ERCOUPE
SERVICE
MEMORANDUM

No. **31**

SUBJECT: Fuel System Operation

FIG. #1

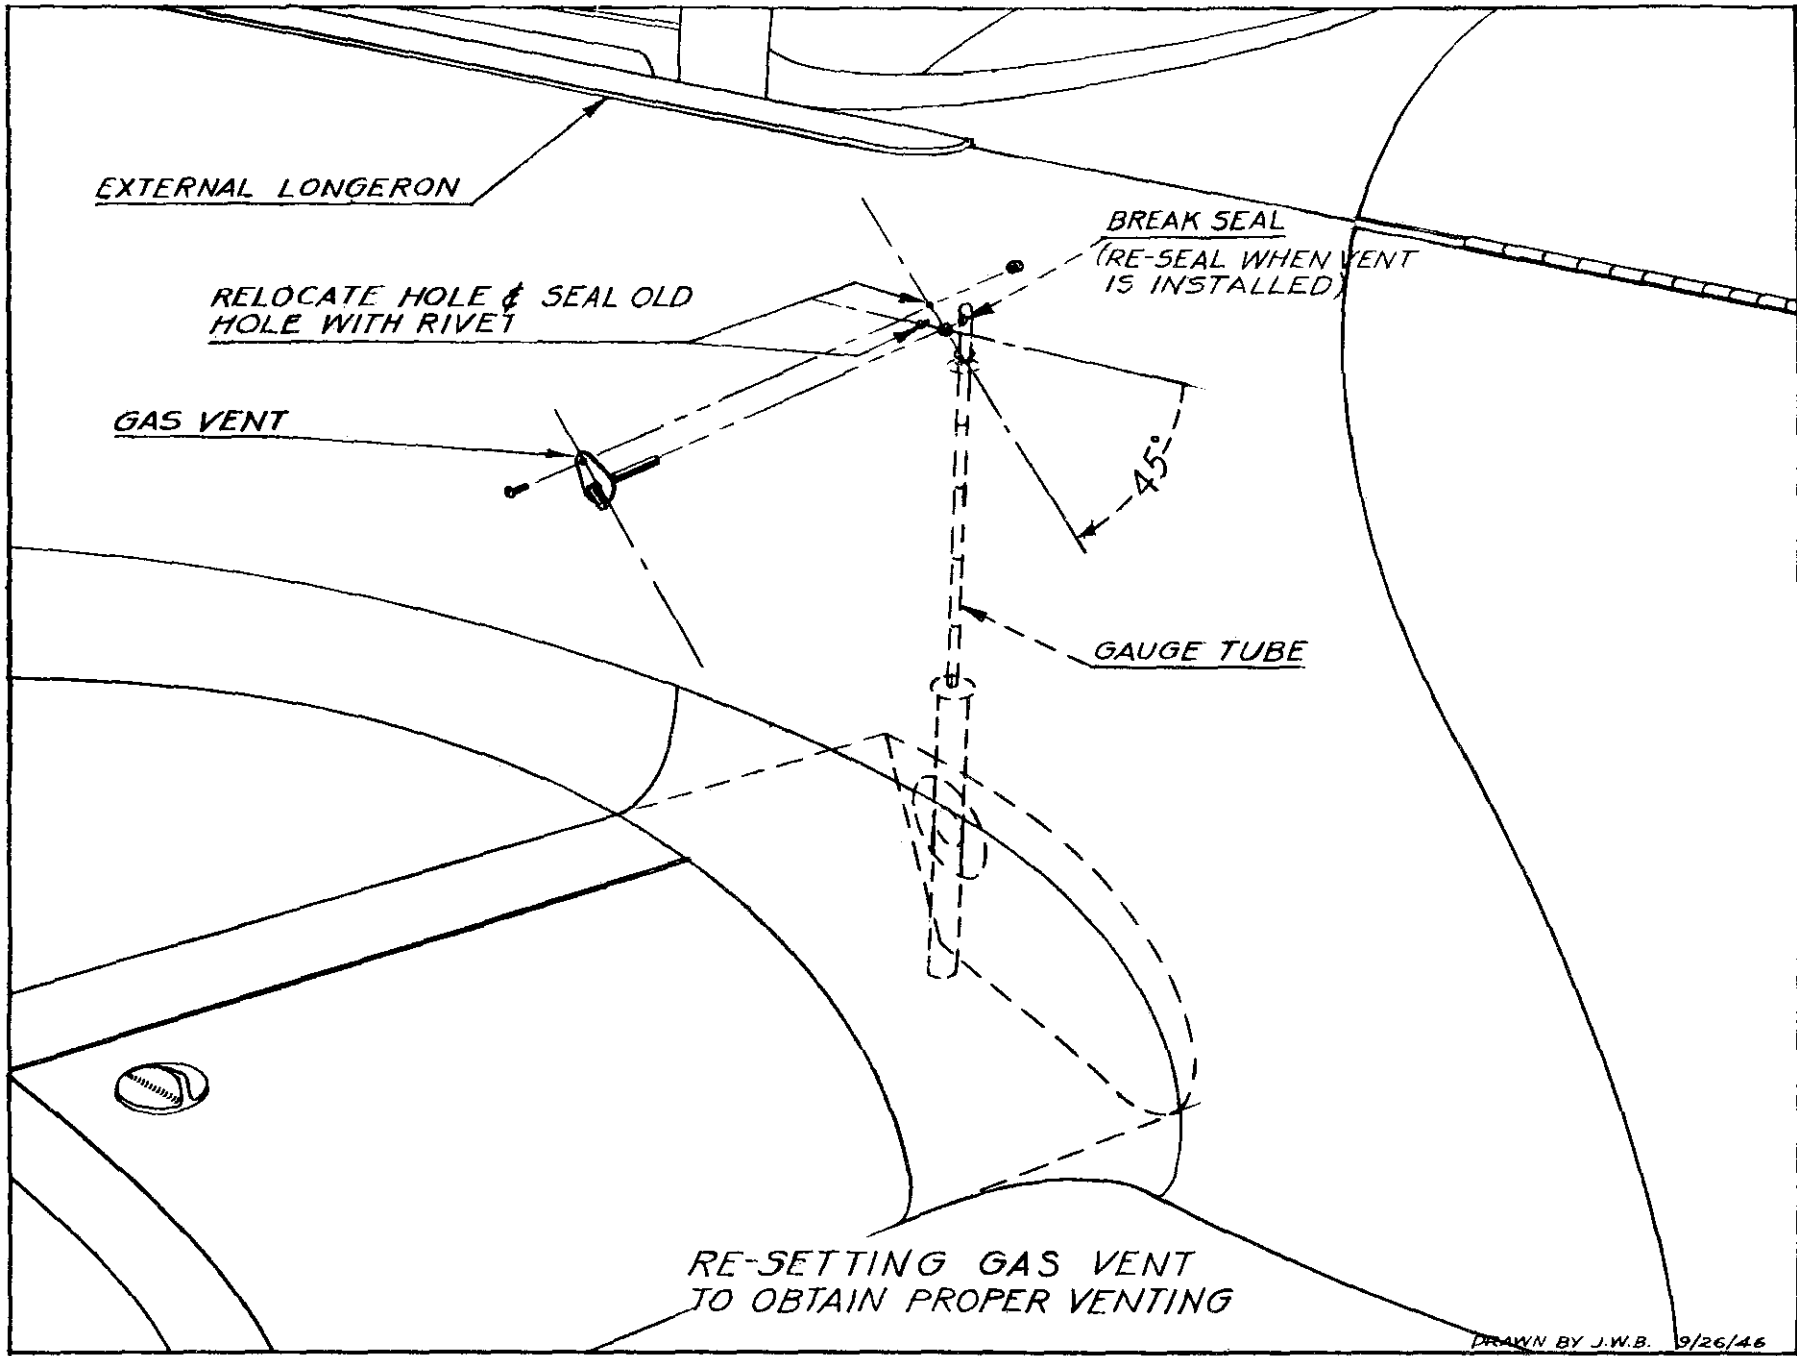
it consists of a float type indicator, encased in a plastic tube. It is marked full, half full, and empty. This gage may give false readings due to improper venting, chiefly the error is reading half full in flight when more than half full of gas. This can be remedied on Ercoupes Serial Numbers 513 to 2623, by complying with the following procedure:

Affected part—415-48089—Vent Assembly

1. Remove 6 x 32 screw and nut which attaches vent to the right side of the fuselage.
2. Break the vent loose from the gage tube by turning the vent.
3. Realign the vent, by lowering the forward end, until it lies in a position from 40° to 45° with relation to the external longeron.
4. Drill a No. 28 hole through the fuselage skin, using the vent plate as a guide.
5. Insert the same 6 x 32 screw that was removed in operation No. 1.
6. Reseal vent to plastic gage tube by using clear nitrate dope, or any suitable cellulose cement. (See illustration No. 1.)
7. Close the original hole with a rivet.

FIG. # 2

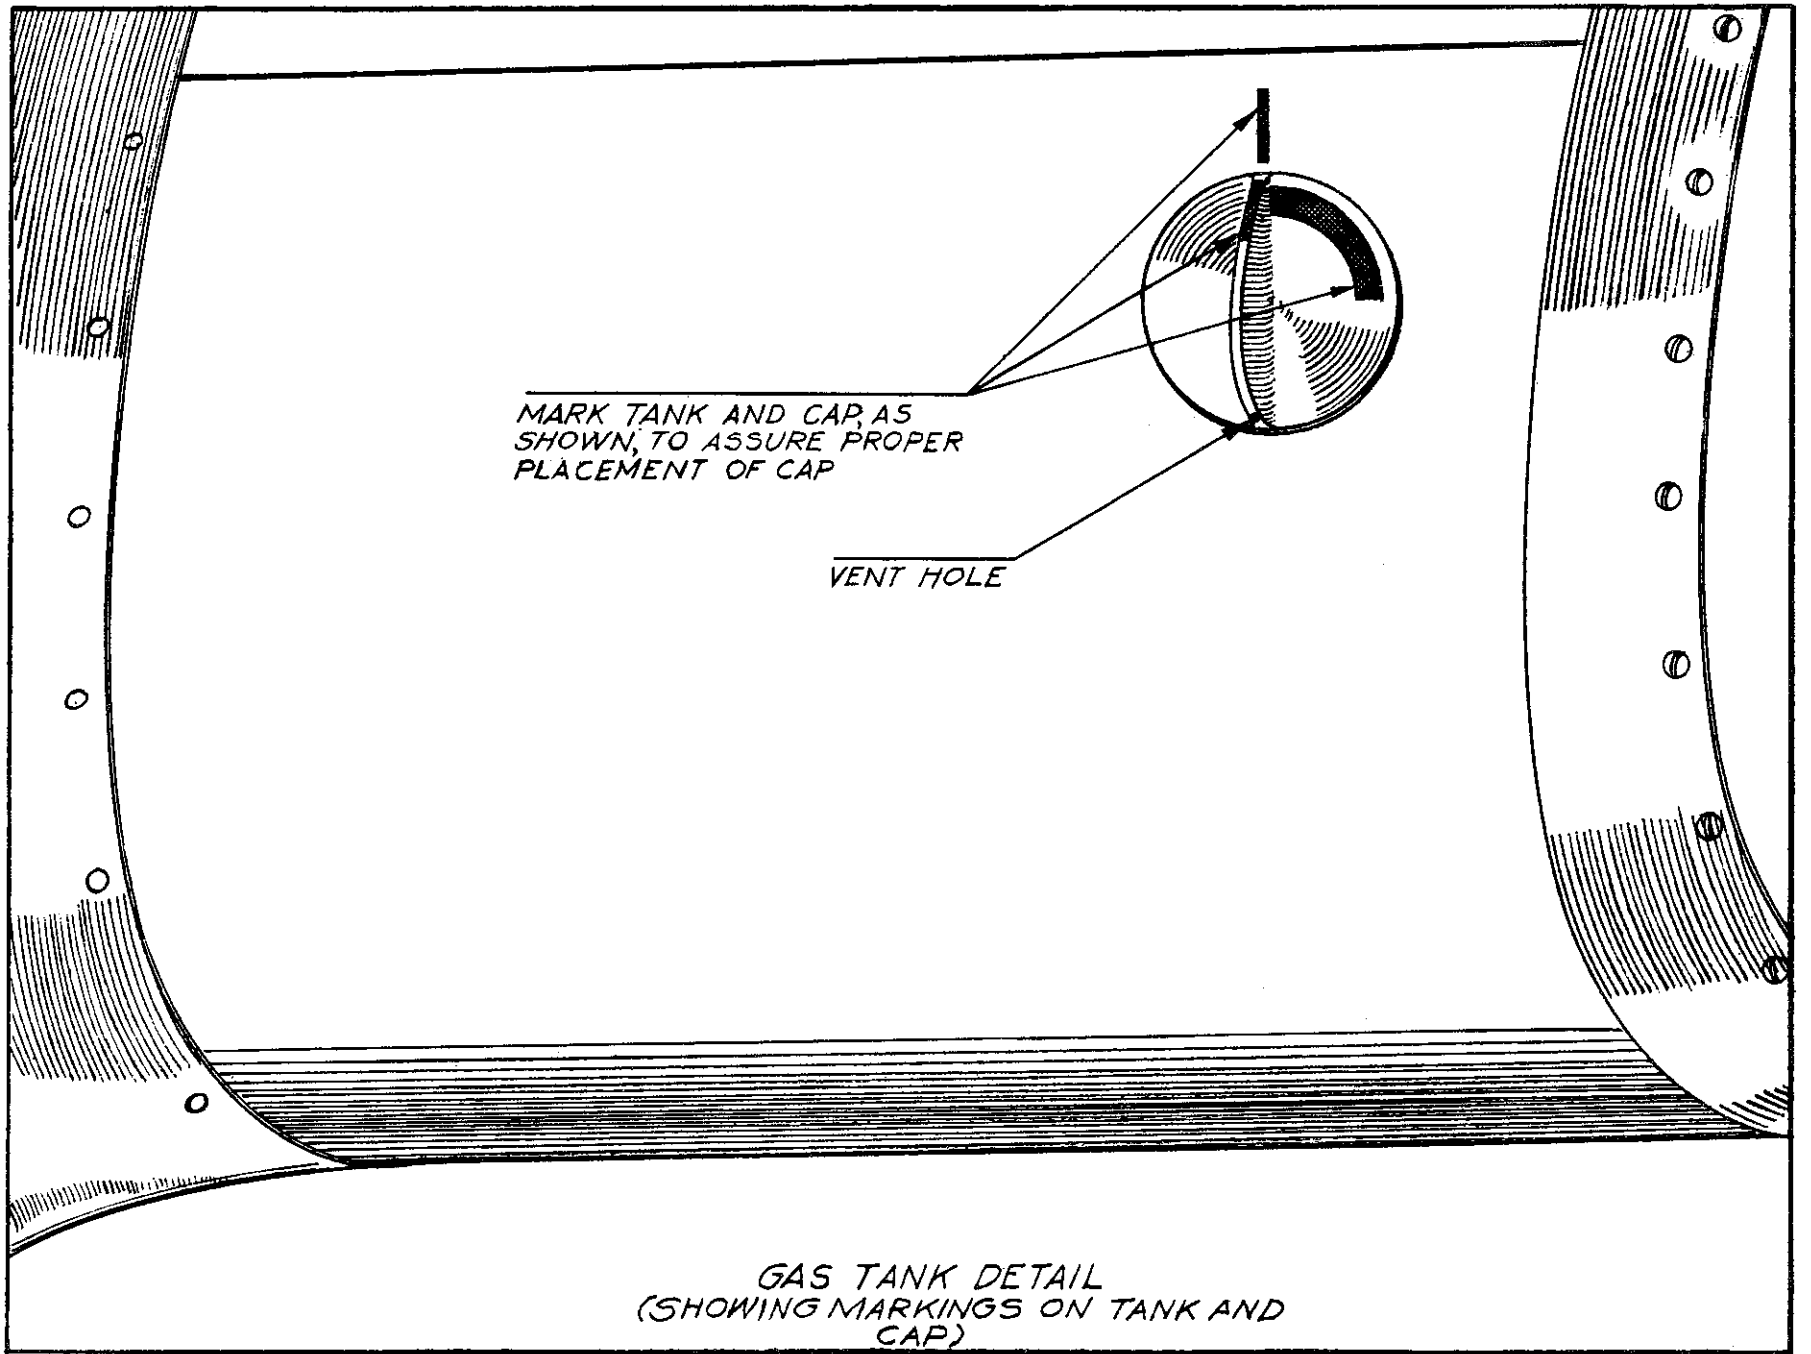
9. It has been the experience of some Ercoupe owners and operators that line mechanics put the wing tank caps on backwards. To prevent malfunctioning of the fuel system, it is imperative that the caps be put on the tanks with the vent hole to the front. This provides venting of each wing tank and will prevent syphoning or unequal flow of the fuel. Unequal flow may result in the fuel pump being unable to transfer all of the fuel from the wing tanks to the fuselage tank.

10. It is recommended that the wing tank cap be marked in a manner to indicate proper positioning. A painted red line on the wing behind the cap to match a painted sector on the cap should be used. The painted sector on the cap should extend from the point of engagement to the locked position, as indicated on accompanying sketch No. 2.
